Addendum No.: 4

Date of Addendum: June 17, 2020

Willard Diloreto Parking Garage
Paul Manafort Sr. Drive
New Britain, CT
CF – RC – 402

E1 CANOPY ELEVATION
SCALE: 1/4" = 1'-0"

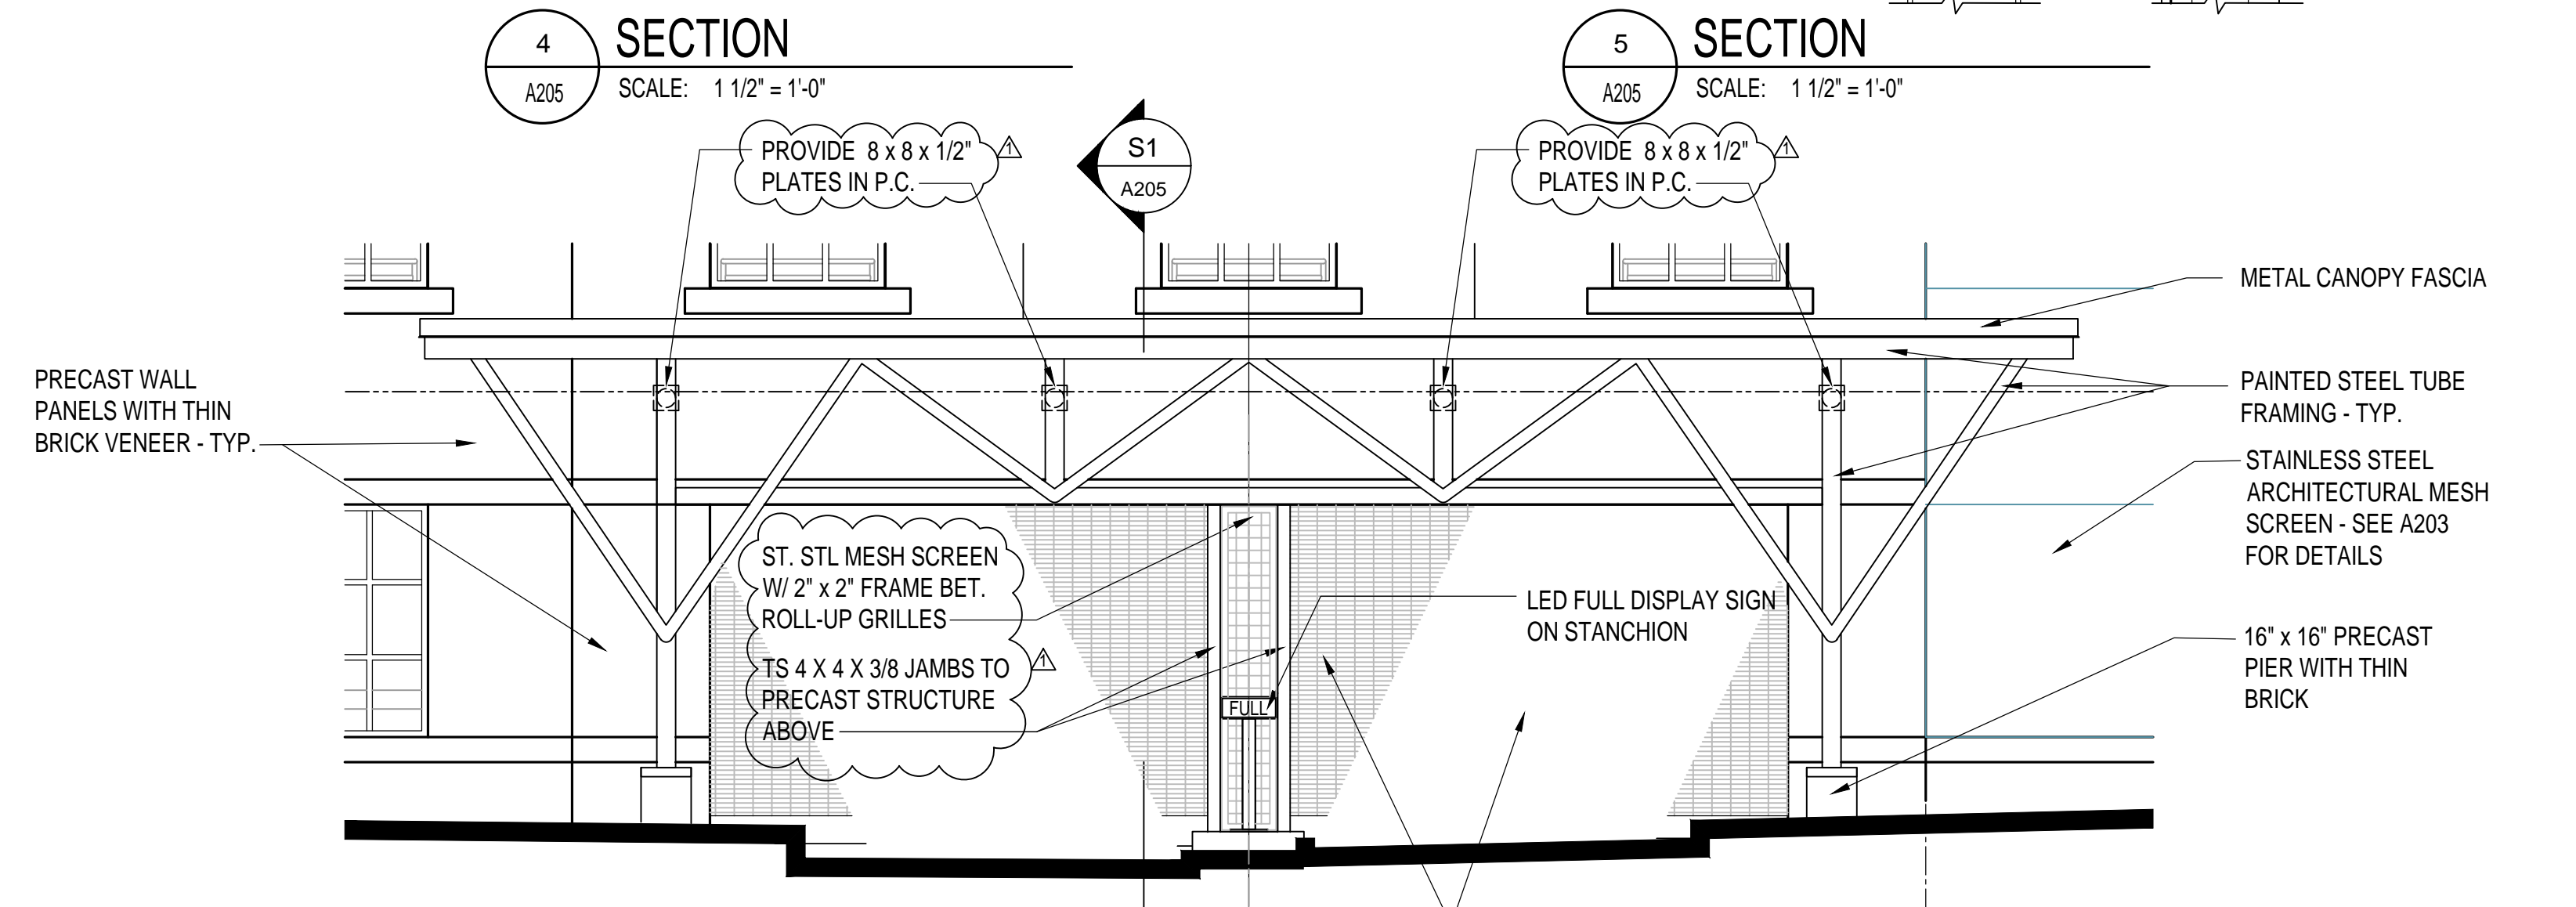
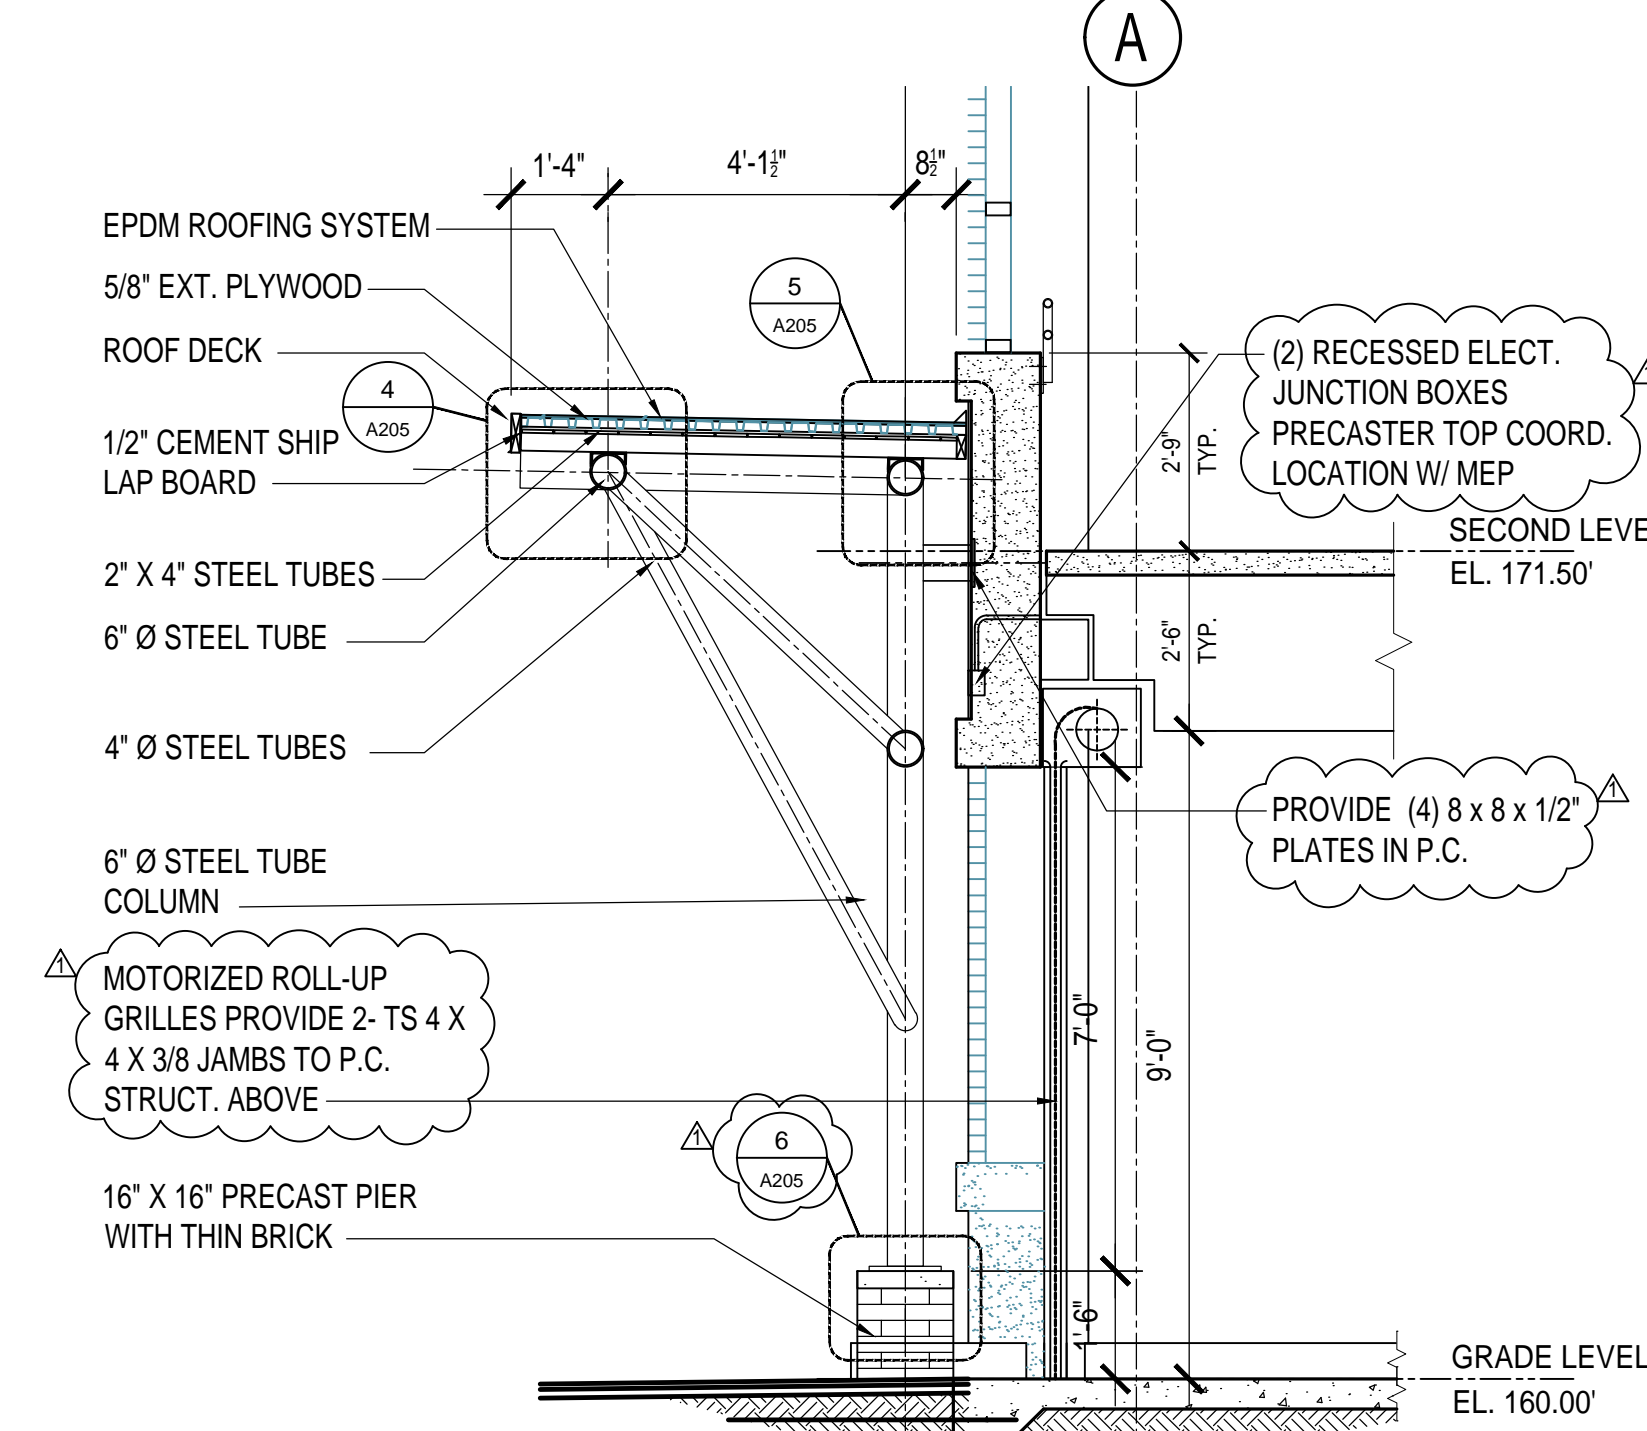
Question: Dwg A205. Please provide corresponding structural drawings and member sizes for canopy structure.

Answer: See revised drawing S202 with Canopy Framing structural details added.
